## **EE MEMORANDUM B2**

**Date:** January, 2016  
**To:** Office  
**From:** Krishna Haridas  
**Re:** Memo 2 – Engineering Evaluation of Existing Vaults 3 and 4  
**File:** 12582B

FOR WILLS WHARF HOTEL, HARBOR POINT, MD

7'-0" X 11'-0" X 7'-0" PRECAST VAULT #3

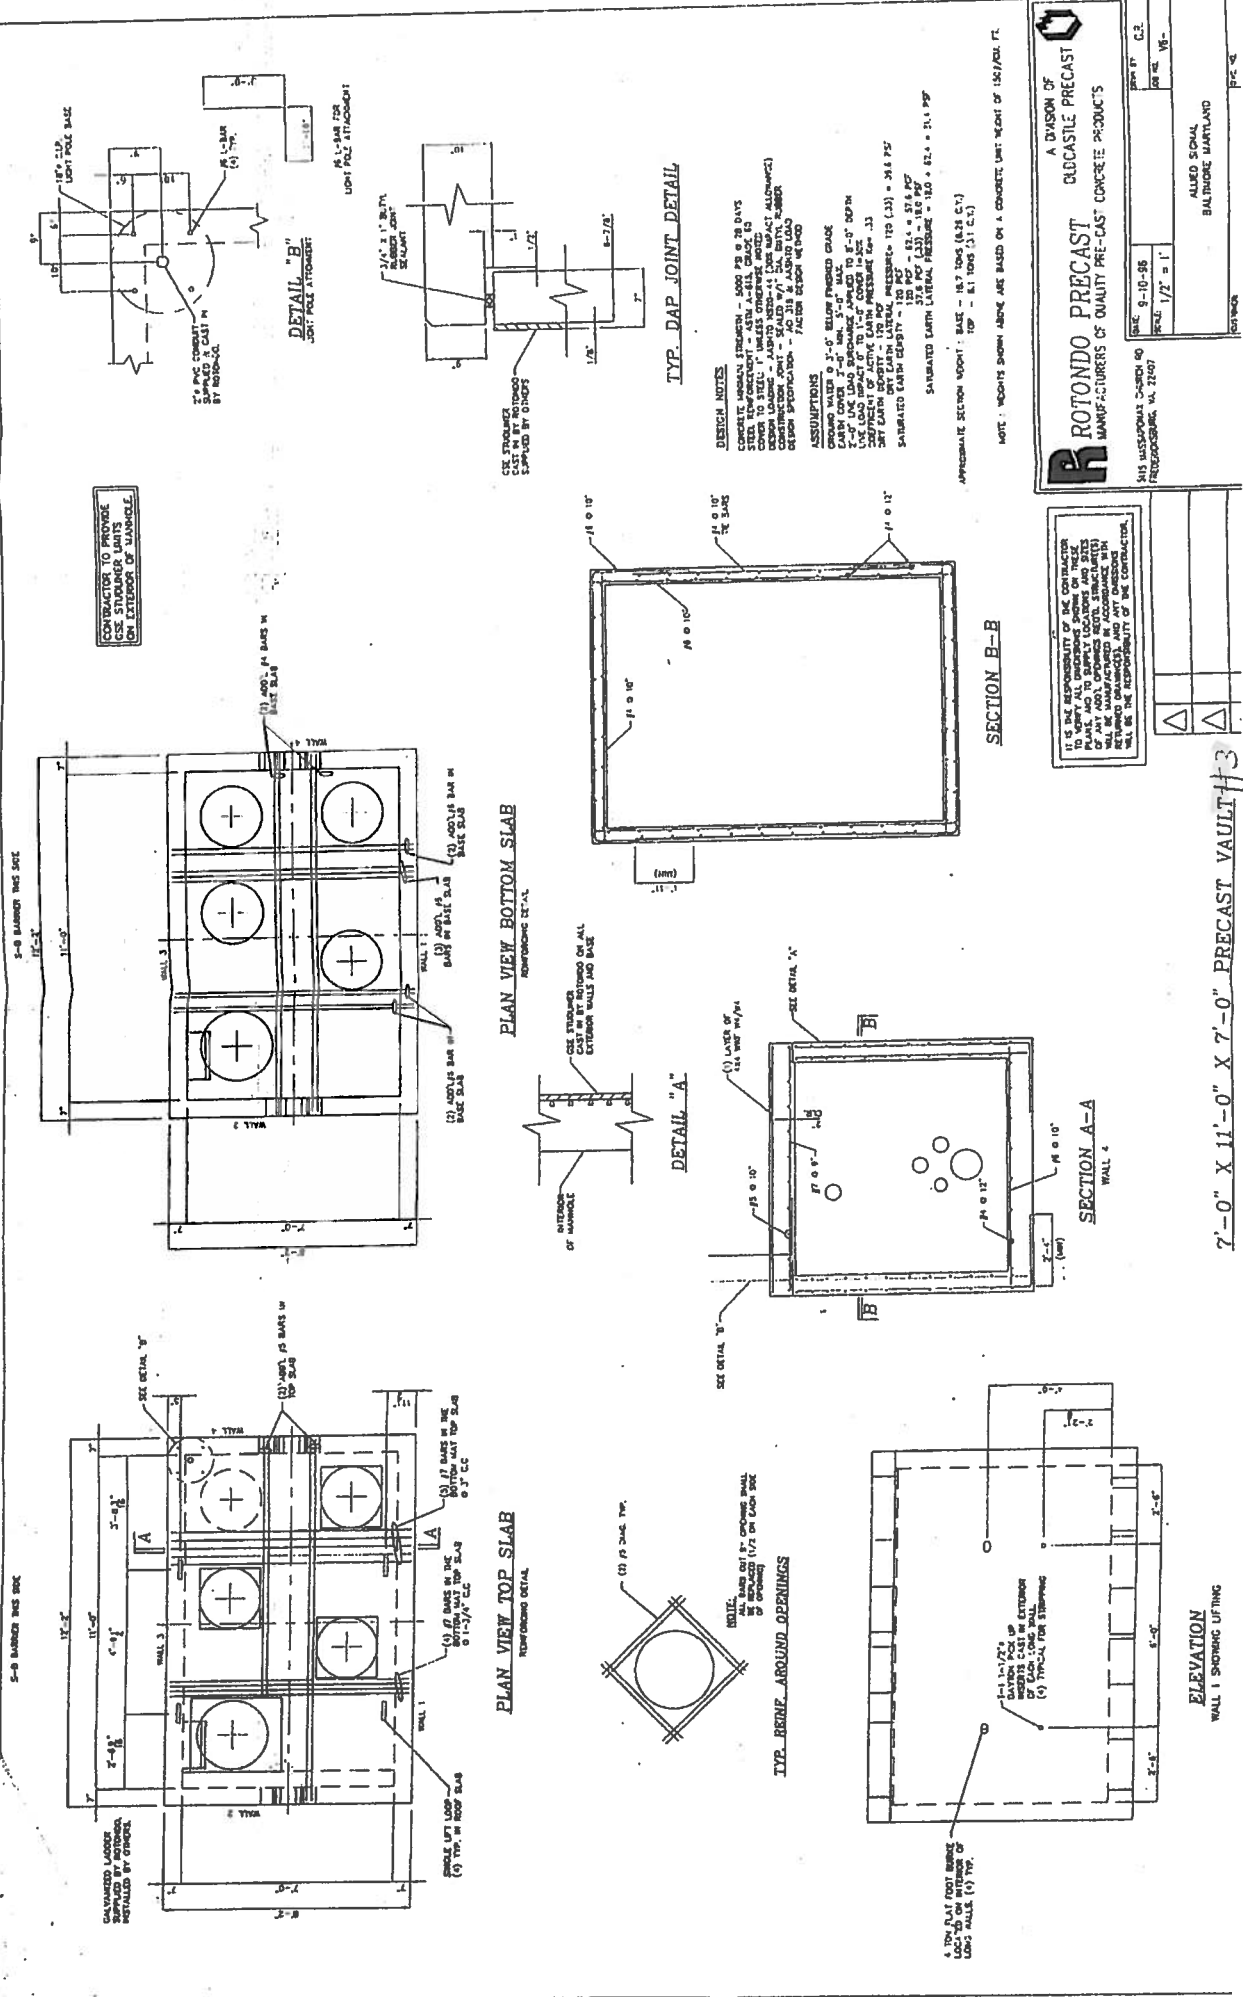
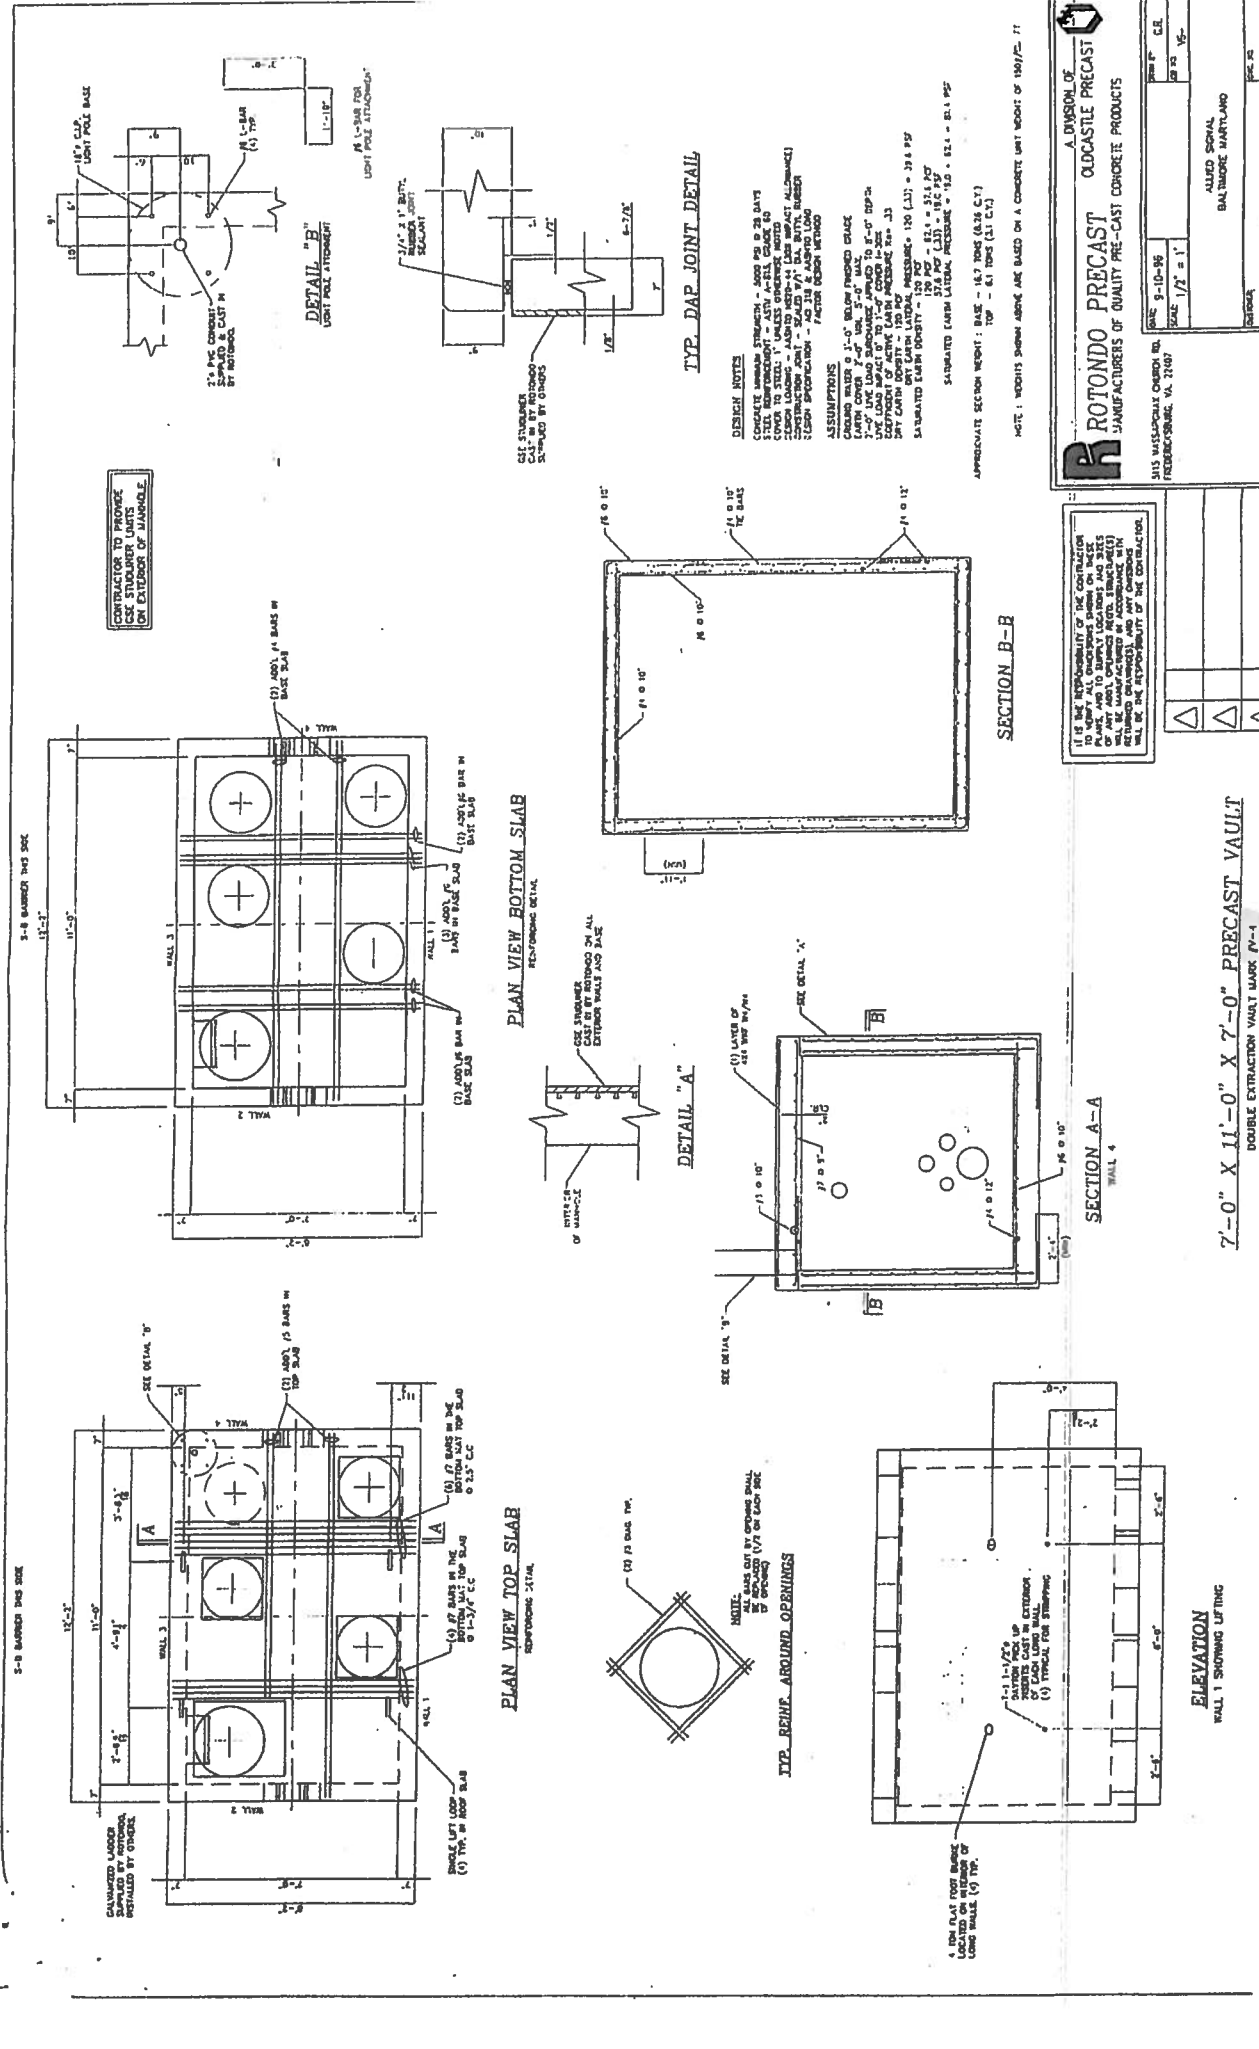
Review of the shop drawings VMH-905, VMH-906, VMH-907 and VMH-908 for the precast vaults supplied by Rotondo Precast and the design package submitted by Black & Veatch indicates Vaults 3 and 4 are designed to carry up to 5 feet of granular fill plus HS20 truck live load. Top of Vault 3 is at Elev. +13.6 and for Vault 4 is at Elev. +12.4 per data provided by CH2M Hill dated 10-16-2015. The construction of proposed Wills Street requires adding fill to the site resulting in approximately 13.4 feet of normal weight of fill over Vault 3 and 4.6 feet of normal weight of fill over Vault 4. A structural capacity evaluation of Vault 4 was not performed as the proposed loading does not exceed that permitted by the designer of vaults

**Vault 3:** MRCE structural evaluation finds that the structural capacity of Vault 3 is inadequate to carry the proposed 13.4 feet of fill and will require structural modifications to handle the load. Structural modifications should follow the latest code provisions.

$M_c < M_u$  Additional reinforcement required.

$V_c < V_u$  Additional reinforcement required.
